Urgent Field Safety Notice

Single Chamber Temporary External Pacemaker 53401

June 2018

Medtronic reference: FA824

FIGURE 1- updated firmware displayed in this image

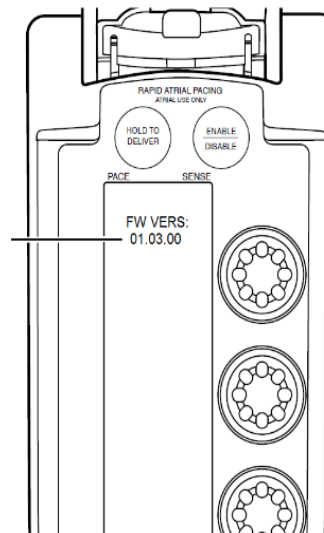
1. Verify whether 53401 EPGs in your possession are affected
2. If your EPG is affected, complete the following:
 - o Determine if the EPG firmware has been updated.
 - Power unit on and view firmware version (Figure 1 below).
 - If firmware version is 01.03.00 or greater, EPG firmware has been updated with correction for this issue. No other action is recommended.
 - If firmware version is 01.02.00, EPG firmware has not been updated. You may arrange to have your Medtronic Service Center update the EPG firmware at no charge.

During power up process, Firmware Version will be displayed for 2 seconds

Recently, Medtronic received approval for a firmware correction that prevents occurrence of this issue. Medtronic recommends customers send affected devices to Medtronic Service to update the firmware to prevent this issue.
